Louisville and Jefferson County Metropolitan Sewer District
700 West Liberty Street
Louisville Kentucky 40203-1911
502-540-6000
www.msdlouky.org

Subject: Story Avenue and Main Street Storage Basin
Minor Project Modification
IOAP Project No. L_OR_MF_020_S_09B_B_A_8
DOJ Case No. 90-5-1-1-08254

MSD is requesting approval of a proposed minor project modification to the Story Avenue and Main Street Storage Basin project (IOAP Project No. L_OR_MF_020_S_09B_B_A_8). This request is part of the ongoing adaptive management review of the approved Integrated Overflow Abatement Plan (IOAP) dated May 2014.

Story Ave & Main St Storage Basin

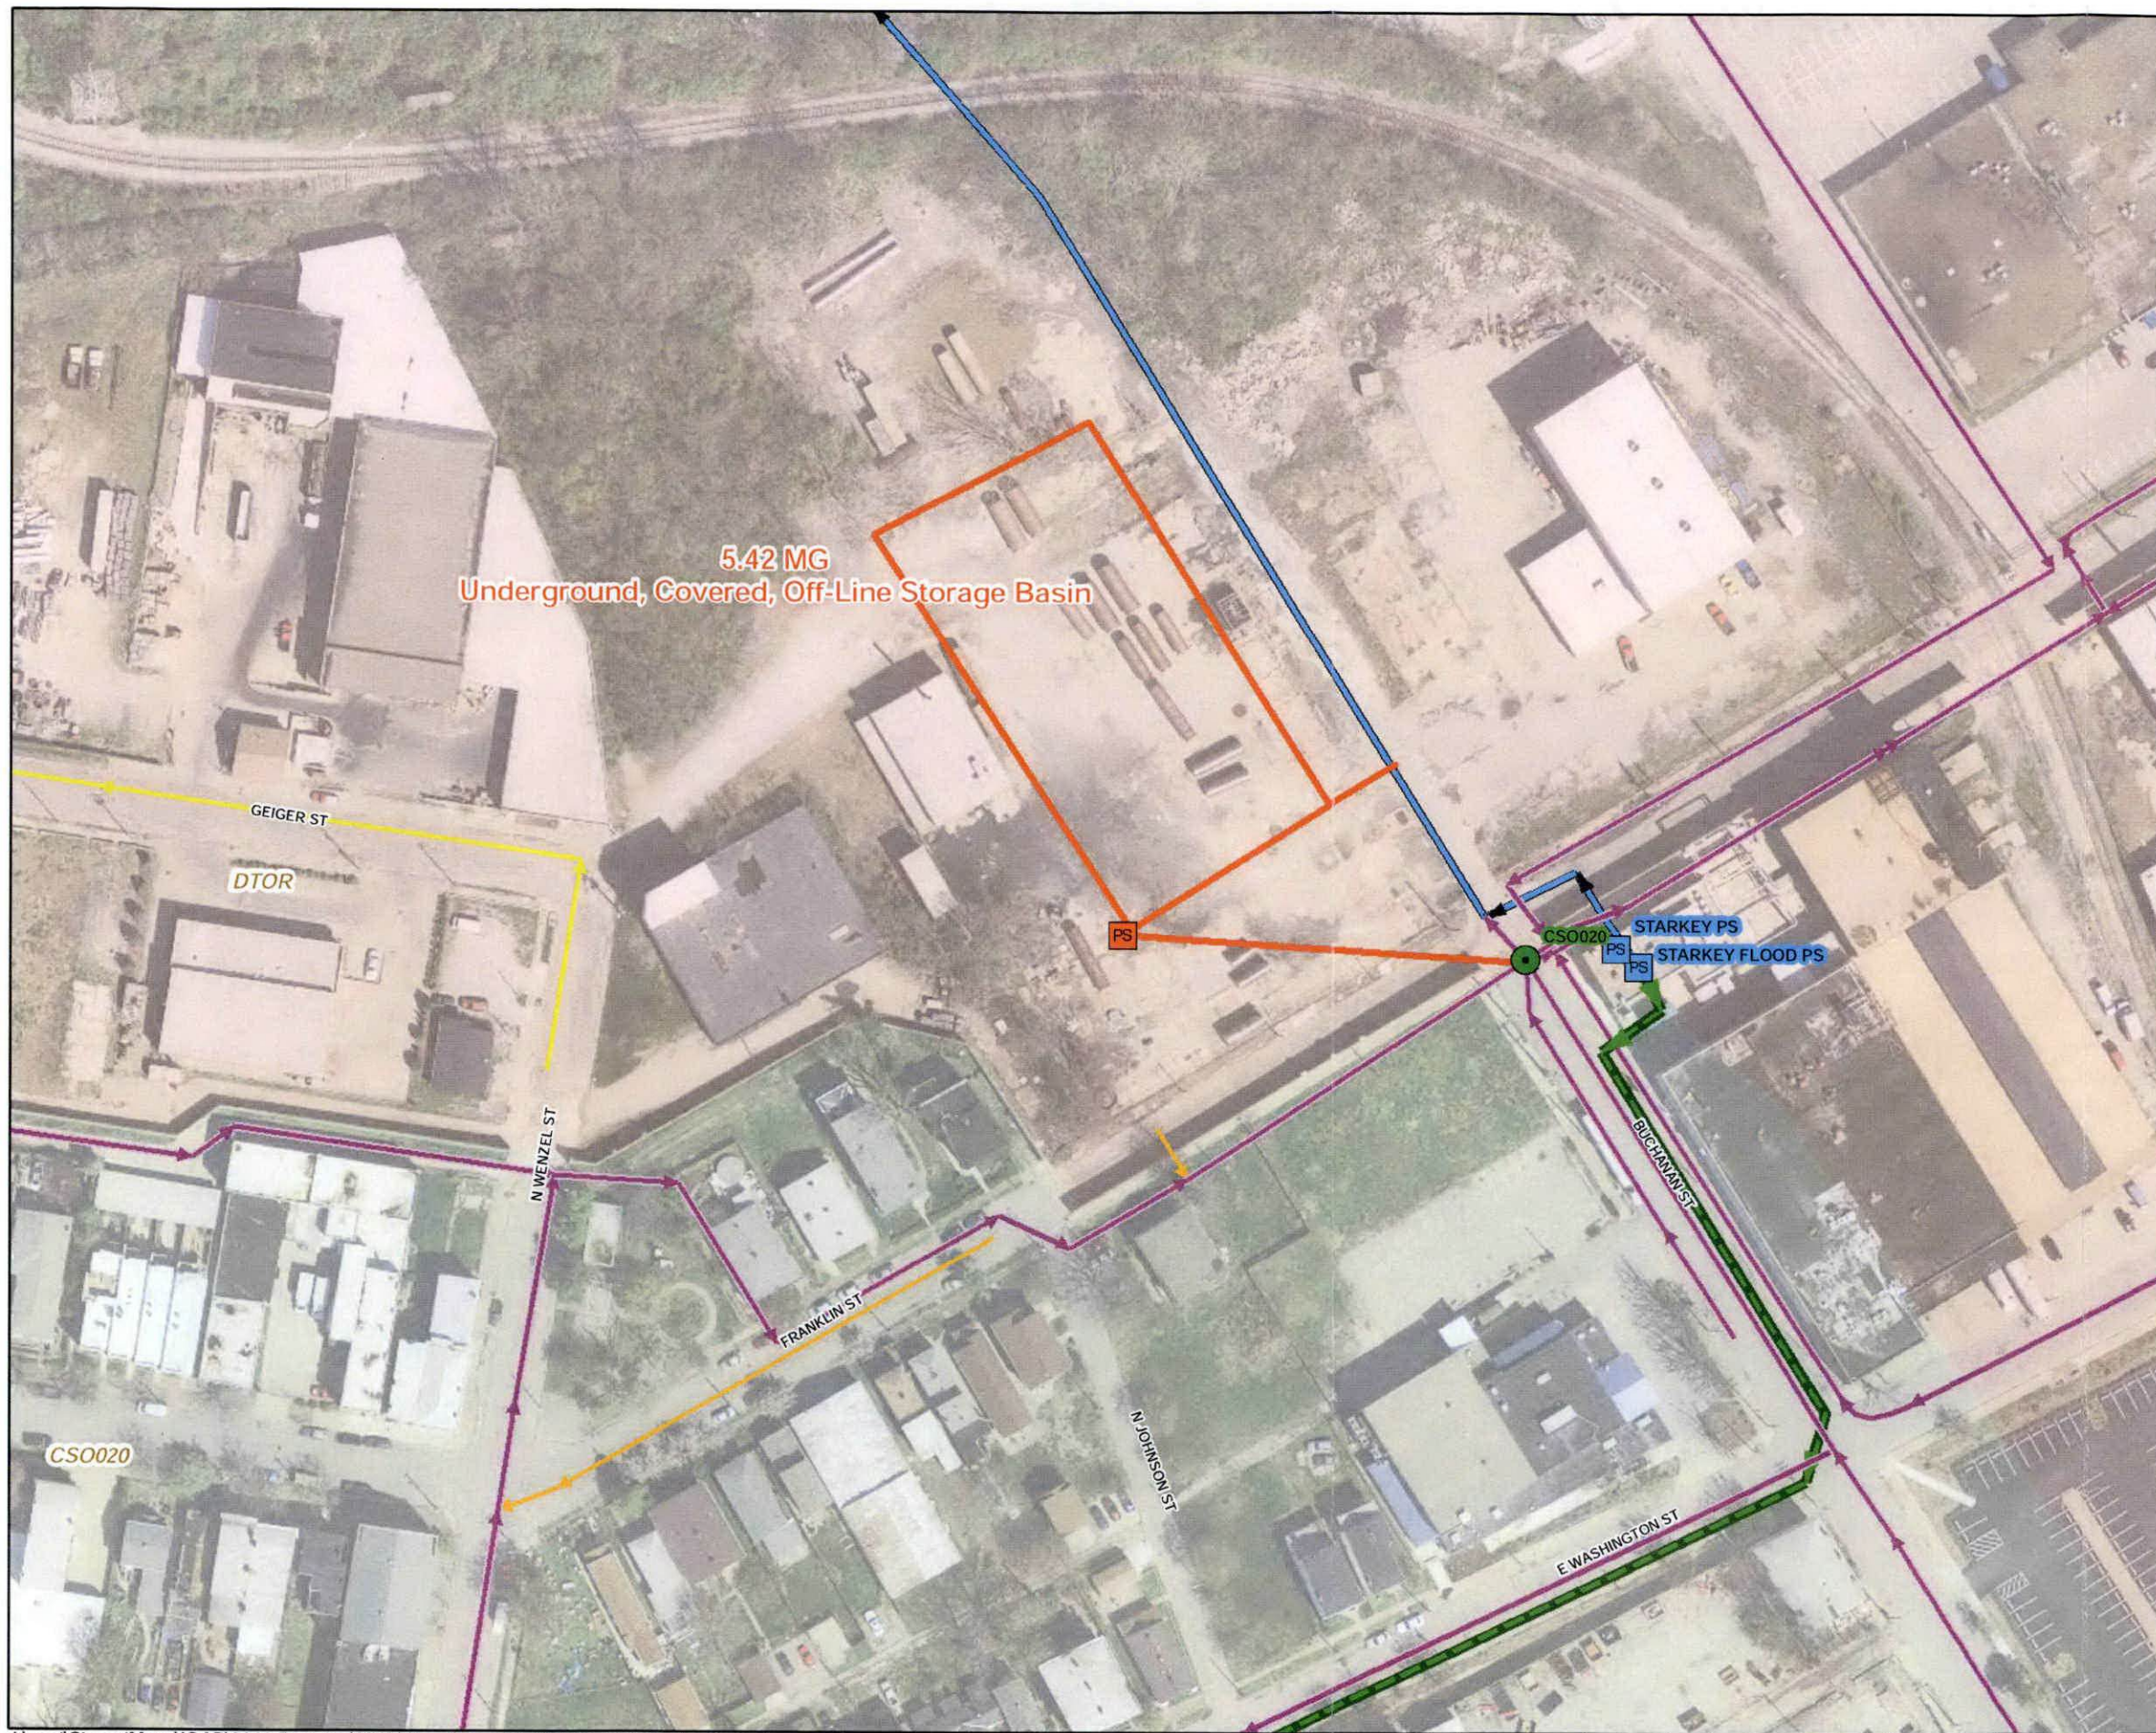
This project modification request includes increasing the Story Avenue and Main Street Storage Basin size from 5.4 MG to 8.3 MG. The level of control is proposed to remain at 8 overflows per year in the typical year. The larger size does not reduce CSO occurrences significantly, but does provide a reduced residual AAOV. No change in project completion date is proposed.

Project Description: This project includes the construction of a 5.42 MG off-line underground covered storage basin for CSO020 to reduce overflows to 8 overflows per typical year. Project assumes that the Starkey Pump Station has a typical, minimum pumping rate of 108 MGD. Additional storage or a higher pump-out rate may be added if deemed advantageous to operational and maintenance flexibility as well as impacts to other downstream CSO control projects.

Project Description: This project includes the construction of a 8.3 MG off-line underground covered storage basin for CSO020 to reduce overflows to 8 overflows per typical year. Project assumes that the Starkey Pump Station has a typical, minimum pumping rate of 108 MGD. Additional storage or a higher pump-out rate may be added if deemed advantageous to operational and maintenance flexibility as well as impacts to other downstream CSO control projects.
